Historic District Commission MEETING AGENDA

Monday, February 10, 2025 - 6:00 PM
Council Chambers, Easton Town Office
14 S Harrison Street

Historic District Commission Staff Report

Historic District Commission Staff Report

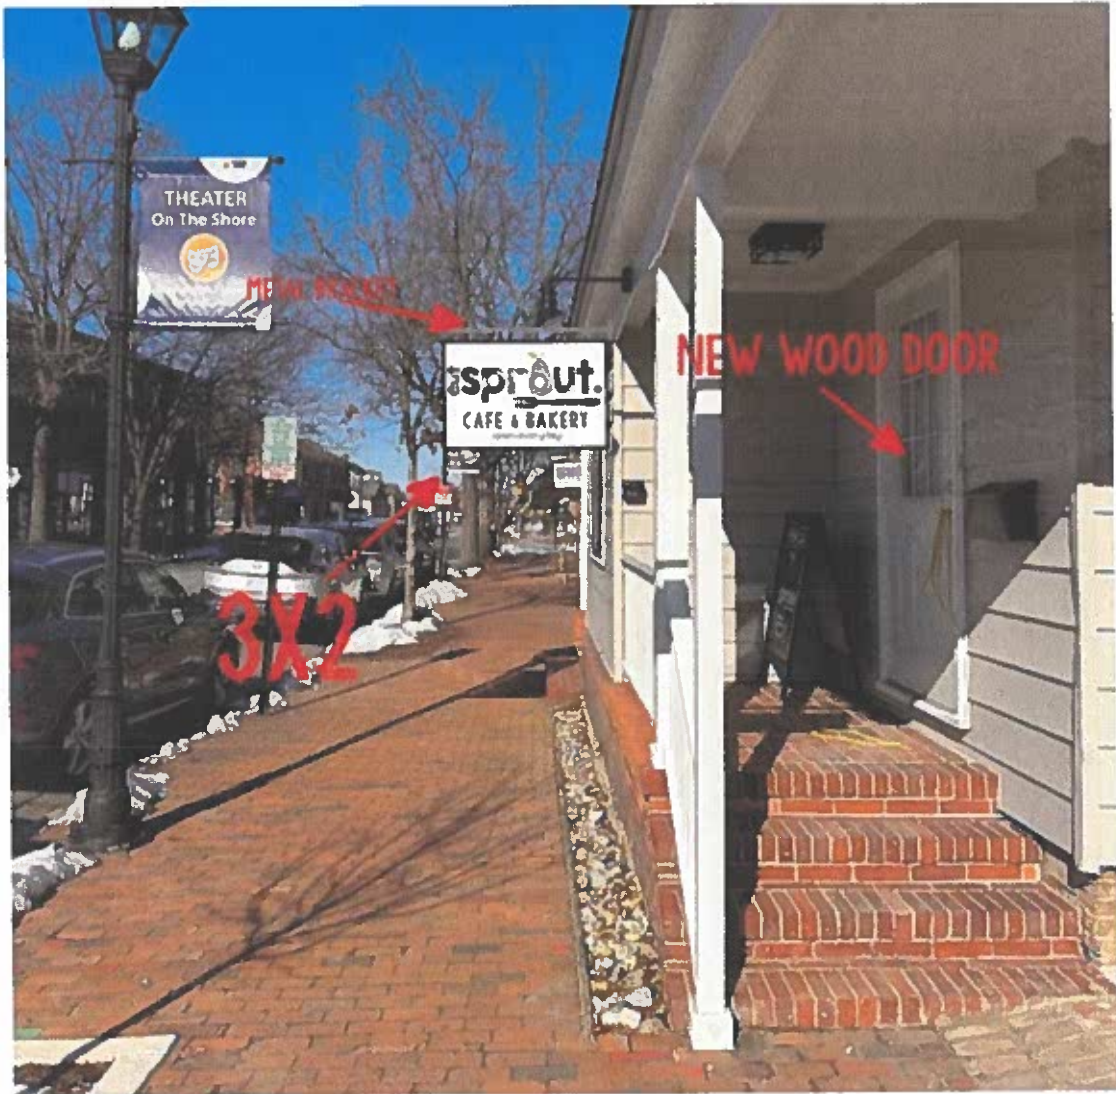
The applicant is proposing to install a 2' by 3' (6 square foot) hanging sign on the front facade of the structure. The sign will be constructed of a composite material and mounted via a metal bracket above the front porch. Additionally, the applicant is proposing to replace the existing front door with a new wood door.

Staff supports a Commission **approval** of this application with a condition regarding the minimum clearance of the hanging sign from grade. The proposed sign meets the dimensional requirements of the Zoning Ordinance and the Design Guidelines. The proposed door is constructed of wood which is an appropriate material for front facades per Guideline 42c. It is also simple in style and incorporates a large glass pane which is typical of commercial properties.

1. The hanging sign shall have a minimum clearance of eight (8') feet above grade and shall not project into a vehicular public way.

Door Four

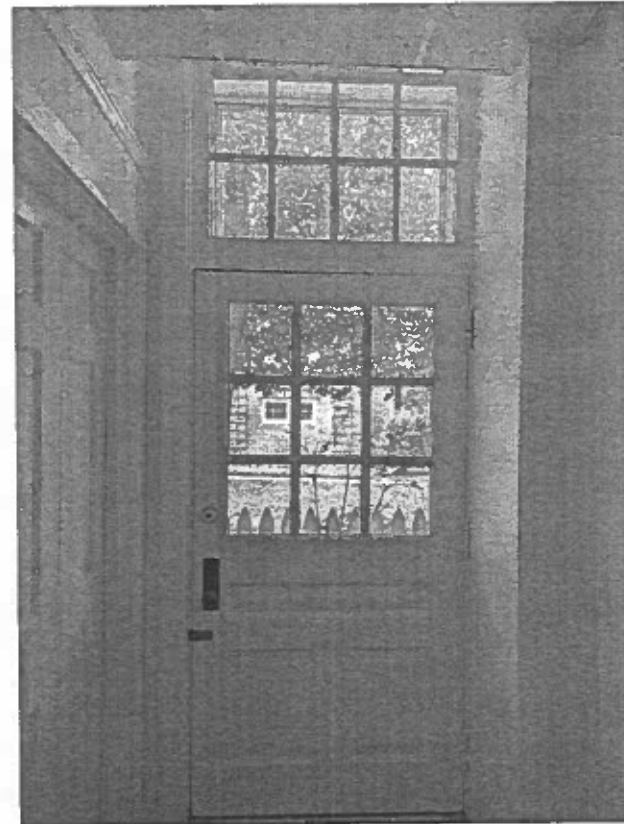
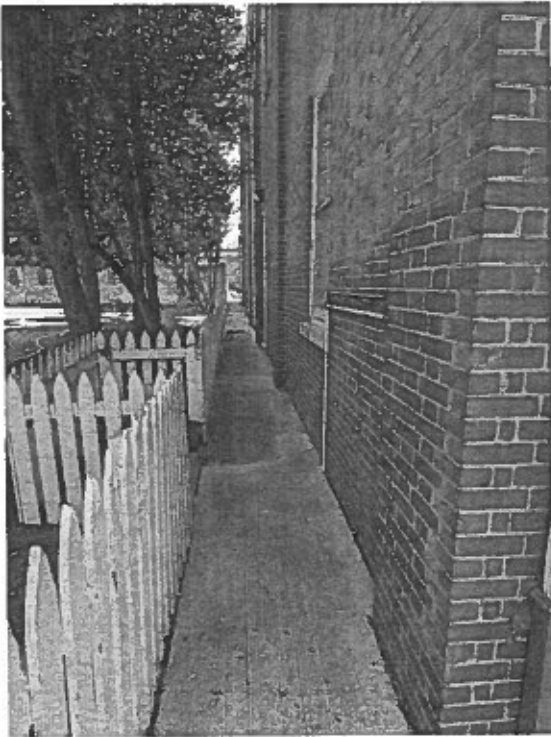
The applicant is proposing to replace four (4) existing exterior doors located on the side and rear facades of the structure with new steel doors. Of the four existing doors, only the door identified in the application as “Door Four” which is located on the northern façade, appears to be historic. New steel doors are necessary to provide added security for the Town Office. This is considered a contributing structure to the Historic District.

Steel or (metal) doors may be appropriate for (use on) later architectural styles, where such materials were originally used, or **non-visible elevations**. On visible elevations, metal replacement doors should match the historic unit.

1. I move that the Historic District Commission **approve the application as submitted**
OR
2. I move that the Historic District Commission deny the application based on the following findings...
